**FINAL  
ENVIRONMENTAL IMPACT STATEMENT**

**Defense Waste Processing Facility  
Savannah River Plant  
Aiken, S.C.**

**February 1982**

**U.S. Department of Energy**

Fig. 3.1. Defense waste processing reference flowsheet. Source: E. I. du Pont de Nemours and Co., modified from *DWPF Technical Data Summary No. 3*, DPSTD-77-13-3, April 1980, Fig. 1.1.

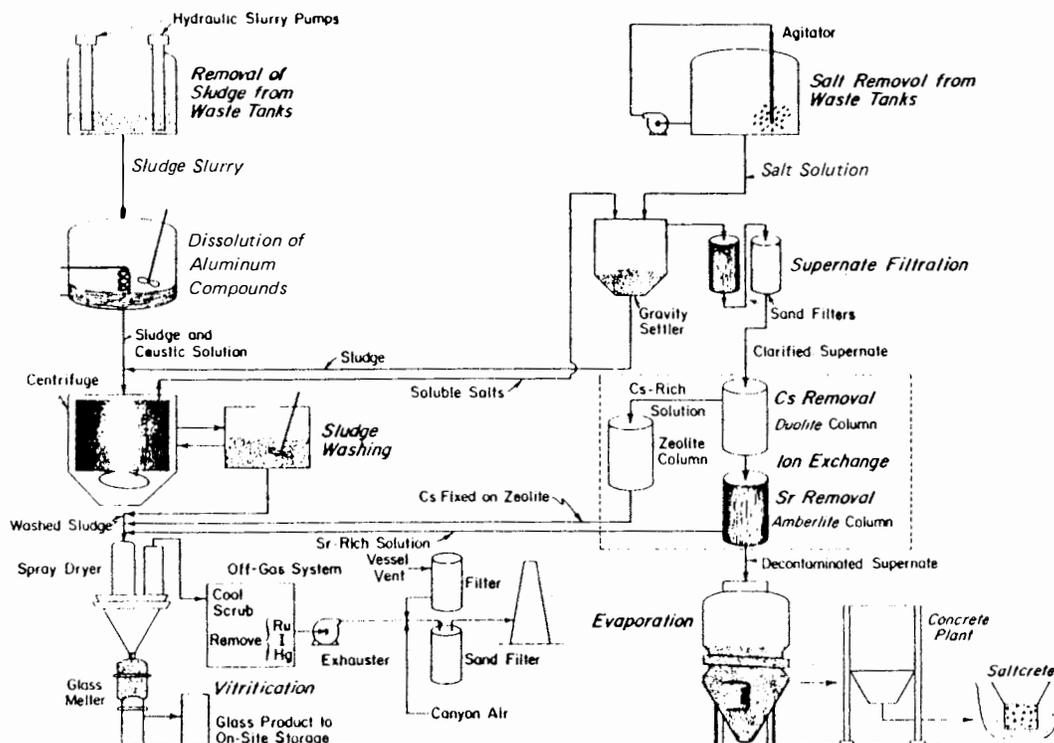
Page 3-3. Comparative Flow Sheets for Waste Processing  
Figure 3.1 shows the reference flow sheet. It is rather complicated. I wish to call it to your attention that a much simpler flow sheet exists. A copy of this flow sheet and a description are enclosed.

As can be seen from the flow sheet, the PE Process requires only that the sludge and/or slurry be pumped to the glass-melting furnace where they are mixed with dry complementary ingredients, sand and limestone. The mixture falls in the furnace and is glassified after boiling off the water. This simple flow sheet omits 12 of the steps which are shown in Figure 3.3, and should be considered in the final EIS.

Are these waste fractions combined or segregated? If they are segregated, Figure 3.1 should show how the supernatant liquid fits into the process flow.

Figure 3.1 shows the reference flow sheet. It is rather complicated. I wish to call it to your attention that a much simpler flow sheet exists. A copy of this flow sheet and a description are enclosed.

As can be seen from the flow sheet, the PE Process requires only that the sludge and/or slurry be pumped to the glass-melting furnace where they are mixed with dry complementary ingredients, sand and limestone. The mixture falls in the furnace and is glassified after boiling off the water. This simple flow sheet omits 12 of the steps which are shown in Figure 3.3, and should be considered in the final EIS.

Are these waste fractions combined or segregated? If they are segregated, Figure 3.1 should show how the supernatant liquid fits into the process flow.

The three forms listed in this summary statement are descriptive. The supernatant liquid is evaporated to precipitated salts. The precipitated salts (saltcake) only constitute a storage form. They are redissolved before being fed to the DWPF process. The flowsheets (Figures 3.1, 3.15 and 3.16) show correctly that two waste streams--sludge-slurry and dissolved salt--are fed to the DWPF.

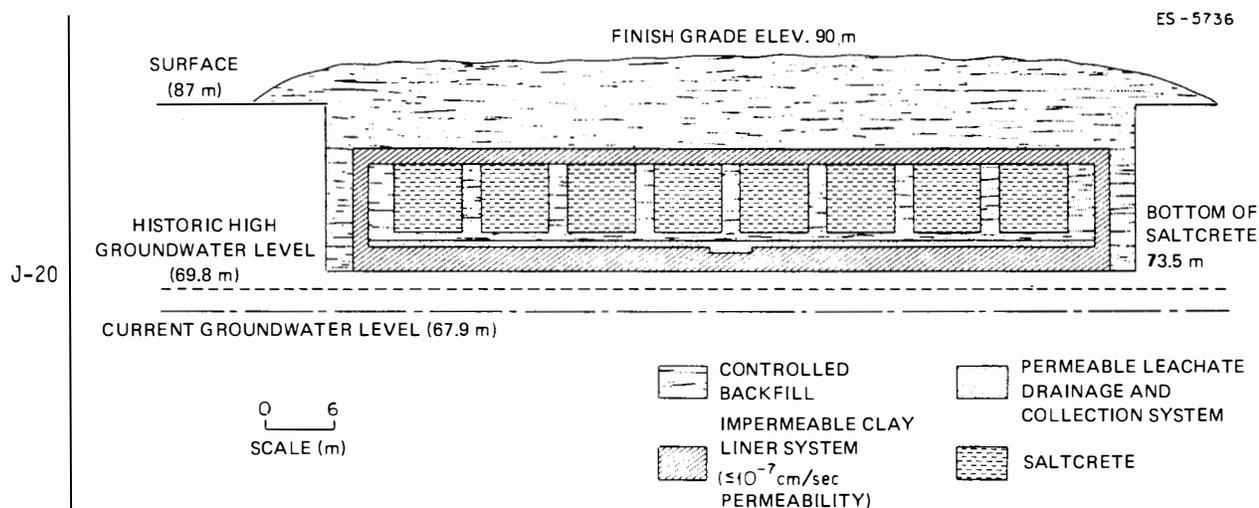
14. Figure 3.8, p. 3-18

The approximate elevations of the existing land surface and the groundwater level, based on site investigations, should be noted on Figure 3.8. Proposed base grades and final grades should also be presented.

15. Figure 3.8, p. 3-18

The proposed saltcrete disposal system, as illustrated in Figure 3.8, will most likely result in a need to continually pump, treat, and dispose of water from the sump system. Consideration should be given to using layered earth materials of significantly different permeability to restrict infiltration from above or capillary rise from below the saltcrete monoliths.

- J-20 14. Figure 3.8, p. 3-18

The approximate elevations of the existing land surface and the groundwater level, based on site investigations, should be noted on Figure 3.8. Proposed base grades and final grades should also be presented.

- J-21 15. Figure 3.8, p. 3-18

The proposed saltcrete disposal system, as illustrated in Figure 3.8, will most likely result in a need to continually pump, treat, and dispose of water from the sump system. Consideration should be given to using layered earth materials of significantly different permeability to restrict infiltration from above or capillary rise from below the saltcrete monoliths.

Figure 3.8 has been revised to incorporate this data.
